## DEVIATION REQUEST AND DECISION FORM

Project Name :	Crossroads North
Schedule No.(s) :	5408001008, 5408001029, 5408001032, 5408001033, 5408001034, 5408001041, 5408001042, 5408001050, 5408001051, 5408001052
Legal Description :	LOTS 12, 13, 14, 15, 16 AND 18, HILLCREST ACRES, ACCORDING TO THE PLAT THEREOF RECORDED MAY 12, 1960 AT RECEPTION NO. 153860, EXCEPT THAT PORTION ACQUIRED BY THE DEPARTMENT OF TRANSPORTATION, STATE OF COLORADO AS DESCRIBED IN RULE AND ORDER RECORDED APRIL 28, 2004 UNDER RECEPTION NO. 204068322, AND EXCEPT THOSE PORTIONS CONVEYED TO EL PASO COUNTY BY AND THROUGH THE BOARD OF COUNTY COMMISSIONERS OF EL PASO COUNTY, COLORADO BY SPECIAL WARRANTY DEED RECORDED DECEMBER 17, 2014 AT RECEPTION NO. 214116021 AND RECORDED DECEMBER 17, 2014 AT RECEPTION NO. 214116022, COUNTY OF EL PASO, STATE OF COLORADO. LOT 17, HILLCREST ACRES, COUNTY OF EL PASO, STATE OF COLORADO, EXCEPT THAT PORTION CONVEYED TO EL PASO COUNTY BY AND THROUGH THE BOARD OF COUNTY COMMISSIONERS OF EL PASO COUNTY, COLORADO BY SPECIAL WARRANTY DEED RECORDED DECEMBER 30, 2014 AT RECEPTION NO. 214119767. LOT 19, HILLCREST ACRES, COUNTY OF EL PASO, STATE OF COLORADO, AS AMENDED BY SURVEYOR'S STATEMENT RECO

SCALE: NOT TO SCALE

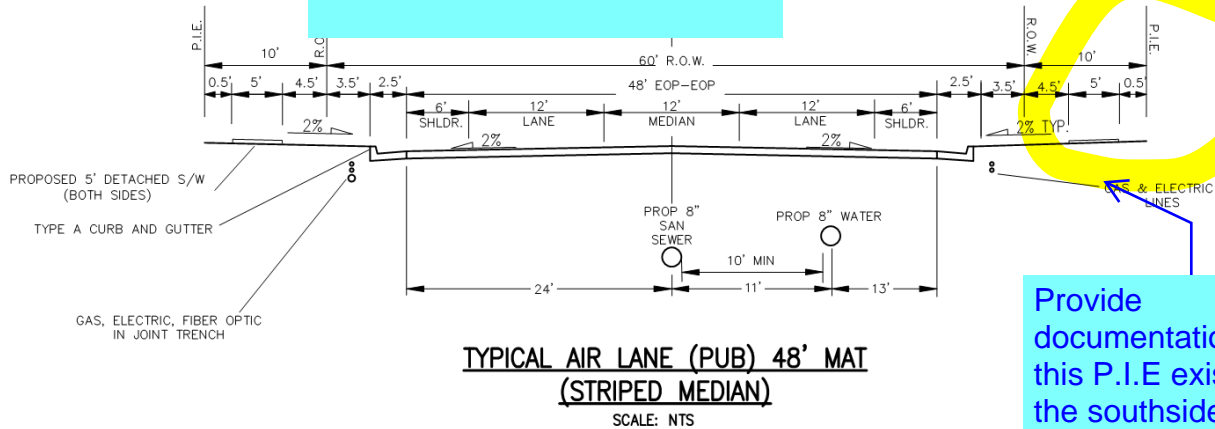
Revise. Air Lane is public road.

Provide documentation that this P.I.E exist along the southside of Air Lane. If it doesn't then the development would need to acquire the necessary easement from the property before the deviation request would be approved.

Plat 1950 (attached) for Hillcrest Acres subdivision does not show this easement.
